Subject Site for SUB

Owner James L. Zboril Lake Nona Central, LLC Applicant Heather Isaacs Lake Nona Land Co., LLC Project Planner Colandra Jones	Property Location: The subject property is located north of Lake Nona Boulevard, east of Heintzelman Boulevard, south of Lake Nona (±104.8 acres, District 1). Applicant's Request: 1. Specific Parcel Master Plan (SPMP) approval for a tennis facility which includes 102 tennis courts, office uses, player development and collegiate facilities, and player lodging. (±65 acres) 2. Request for Major Subdivision Plat to create the Preliminary Plat for the new tennis facility (±104.8 acres).	Staff's Recommendation: Approval subject to the conditions in the staff report.
Updated: October 31, 2014

MASTER PLAN ANALYSIS

ROADWAY CROSS-SECTIONS—USTA BOULEVARD

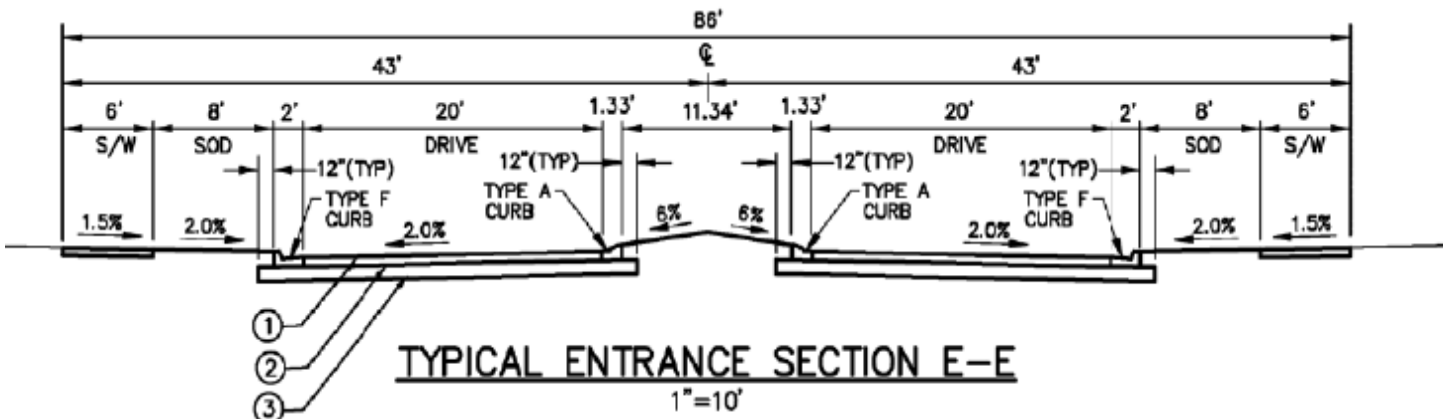
The full build out four lane cross section shall be revised as per the condition of the Transportation Planning staff.
